PROFILE ALIGNMENT AND GRADE OF P.C. 8440
 SANITARY SEWERS PAGE 1
 CONSTRUCTED IN

TRACT N^o 31033
 PRIVATE CONTRACT NO. 8440

W.S. 70
 3 SHEETS, 6 PAGES
 DATE: APRIL 21, 1970
 SCALE: AS SHOWN
 PREPARED IN THE OFFICES OF
 CONSOLIDATED ENGINEERING CO.,
 6645 WEST OLYMPIC BOULEVARD,
 BEVERLY HILLS, CALIFORNIA 90211
 REG. C.E. NO. 10915
 FOR LEGEND SEE PLAN NO. 5.1

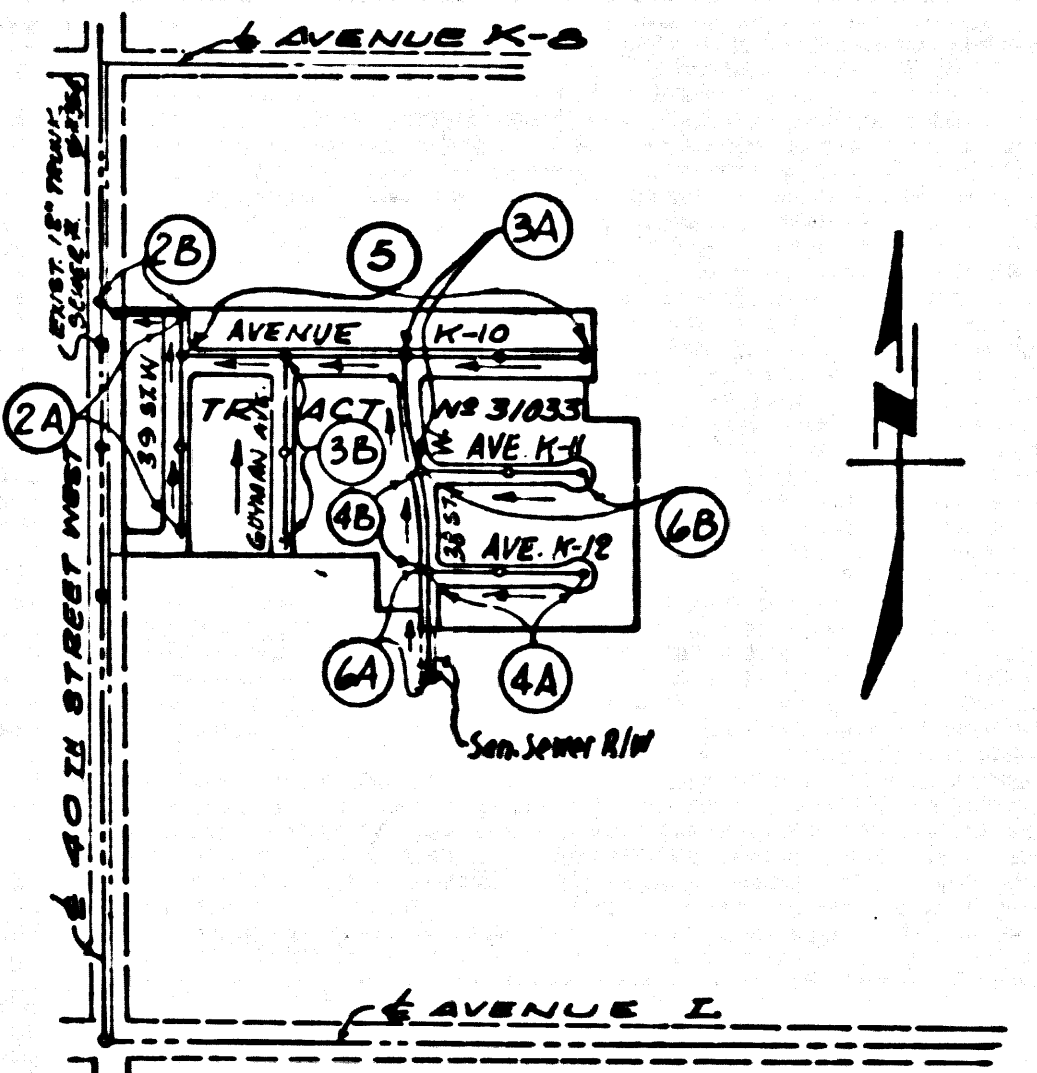
REVISION 5-19-70
 Top of Curb and Sewer Invert Grades have been Revised on the Following Streets:

STREET	From	To	Station
38TH ST WEST	5A	100.00 to 4105.50	
	6B	4105.50 to 4171.61	
AVE. K-11	6B	4171.61 to 4155.41	
AVE. K-12	4A	4155.41 to 4177.00	
AVE. K-10 (REVISED)	5	4177.00 to 4150.00
